IMPACTS OF BARGE TRAFFIC ON WAVES AND SUSPENDED SEDIMENTS OHIO RIVER AT RIVER MILE 581

**IMPACTS OF BARGE TRAFFIC ON WAVES AND SUSPENDED SEDIMENTS:
OHIO RIVER AT RIVER MILE 581**

Appendix C. Comments and Responses on Draft Report

Figure 6. Barge configurations used in the field experiment

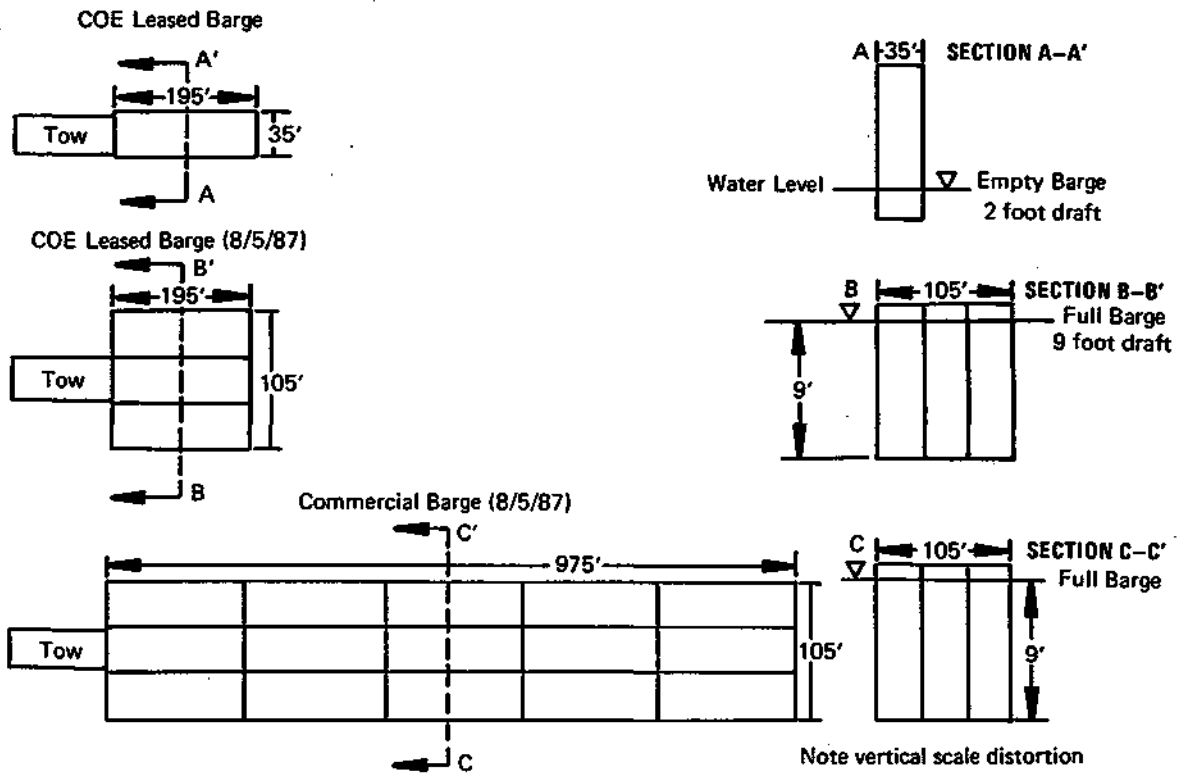
Comment 22: Figure 6 shows 3-wide unloaded barges were used. Only 3-wide loaded were used.

Response: Figure 6 has been corrected.

Figure 17. Variations in suspended sediment concentration with time for ten events

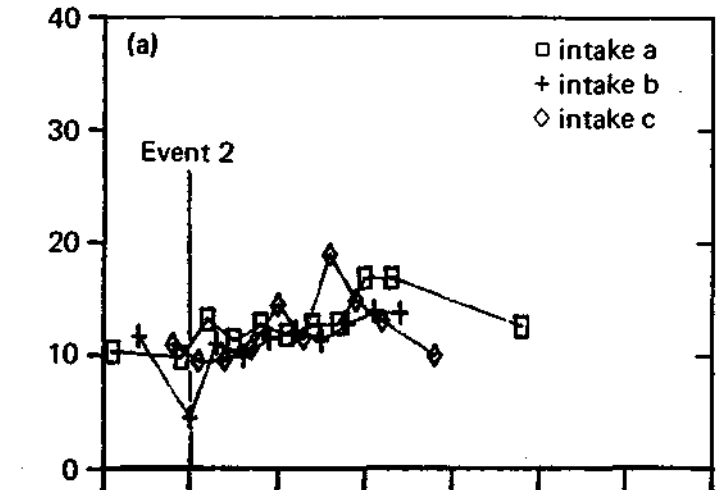
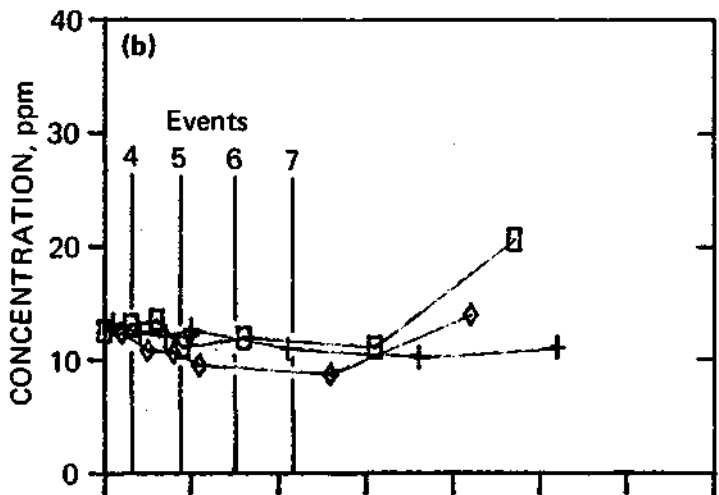
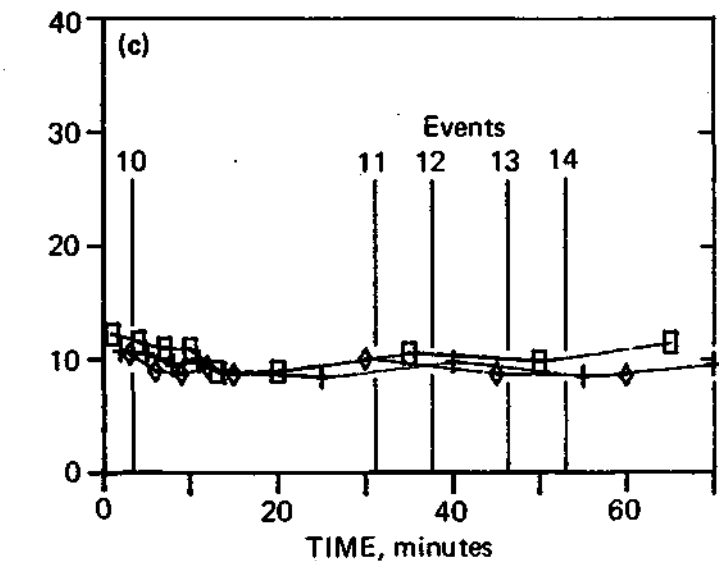
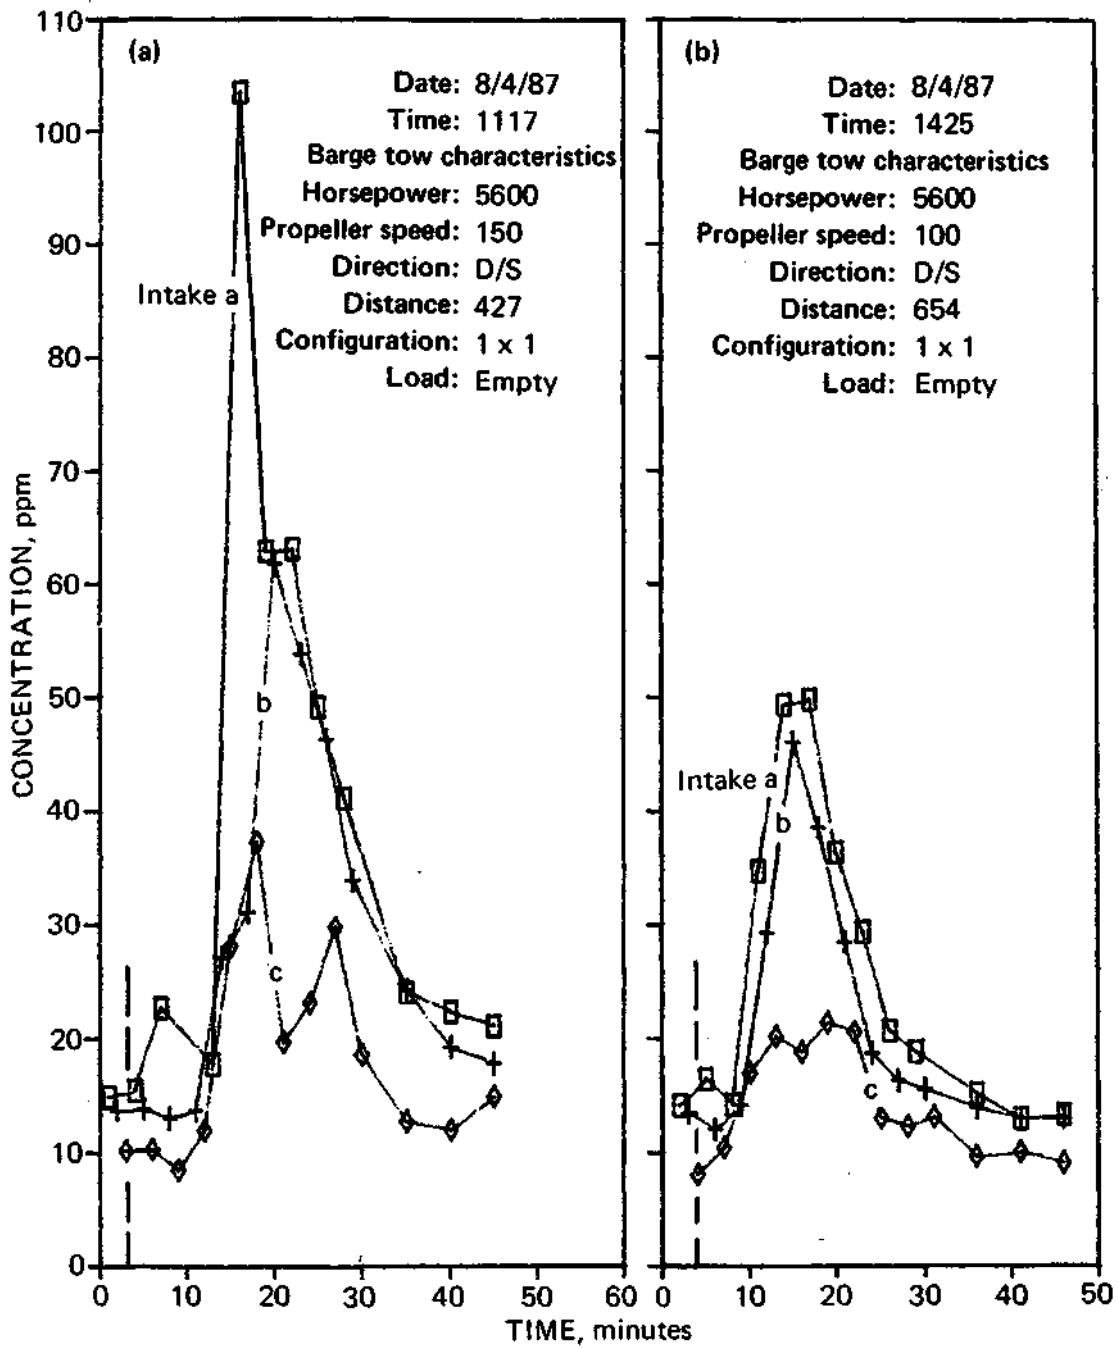
Comment 1: Abstract. The fifth sentence states that the "1500 HP" tow caused a clear increase in suspended sediment, while Figures 17 and 18 indicate that only the 5600 HP tow caused a clear increase in suspended sediment. The Abstract should indicate that these events were only a portion of the total number of events.

Response: Abstract corrected.
